NORFOLK VANGUARD OFFSHORE WIND FARM

Secretary of State Additional Information Request

**Natural England advice on Flamborough and Filey Coast (FFC) SPA
PVAs and in-combination assessments**

19th November 2021

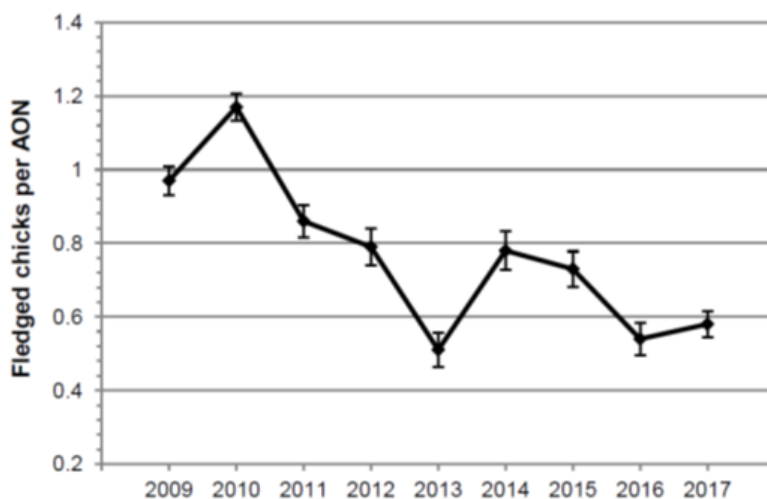
59. There is no evidence to suggest that the future population trend will be significantly different from the current trend of 0.37% per annum (2000-2017), for example productivity at the colony has not been increasing in recent years (see Figure A2.01) (Aitken et al. 2017). So, based on the review of growth rates above, it seems reasonable to assume that the FFC SPA colony growth rate will be <1% per annum.

60. Therefore, as this feature has a restore conservation objective, and because there are indications that the predicted level of mortality would mean the population could decline from current levels should it currently be stable, **it is not possible to rule out AEol of the kittiwake feature of the FFC SPA for collision impacts from in-combination with other plans and projects, for all projects up to and including Hornsea 3, Norfolk Vanguard, Norfolk Boreas, East Anglia One North and East Anglia Two, irrespective of whether Hornsea 4, DEP and SEP are included in the totals or not.**
